ROUNDEL HOMES INC. (PH-2)

PROJ. No. 23-01

LOT No. 58

CURRENT DRIVE

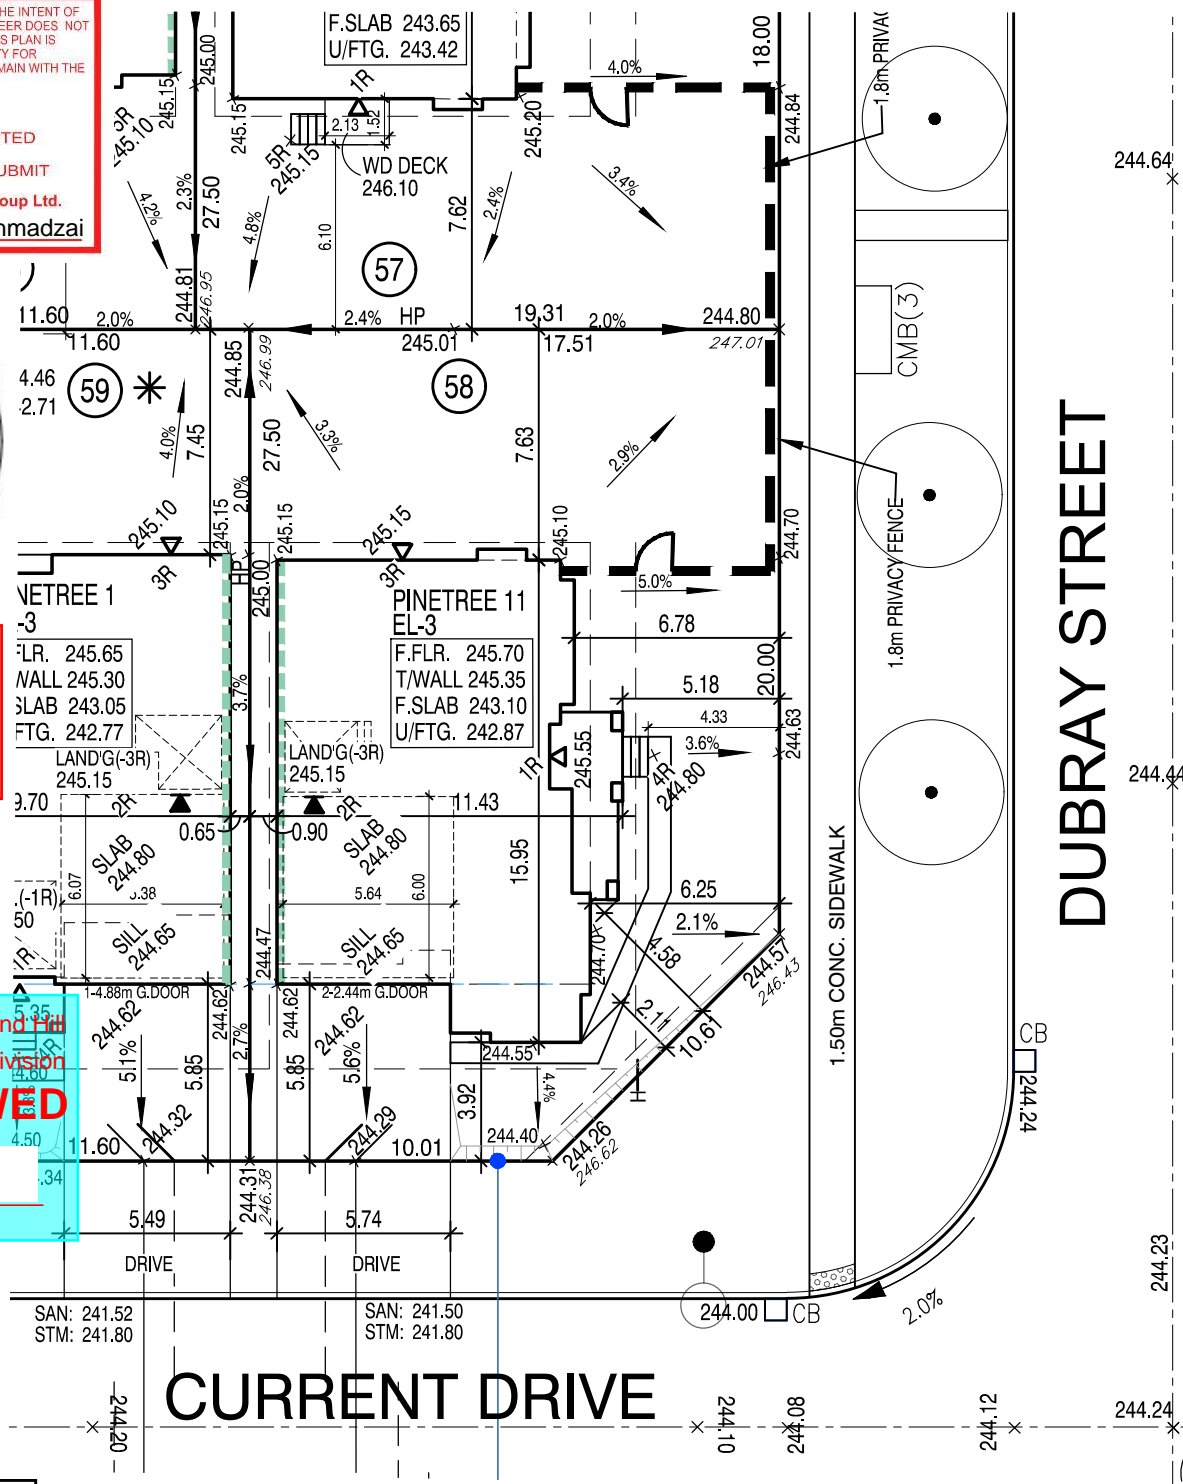
No unprotected openings permitted within 1.2 metres of the lot line as per 9.10.14 of the Ontario Building Code.

45 MINUTE RATED WALL
WITH SIDE YARD < 1.2m
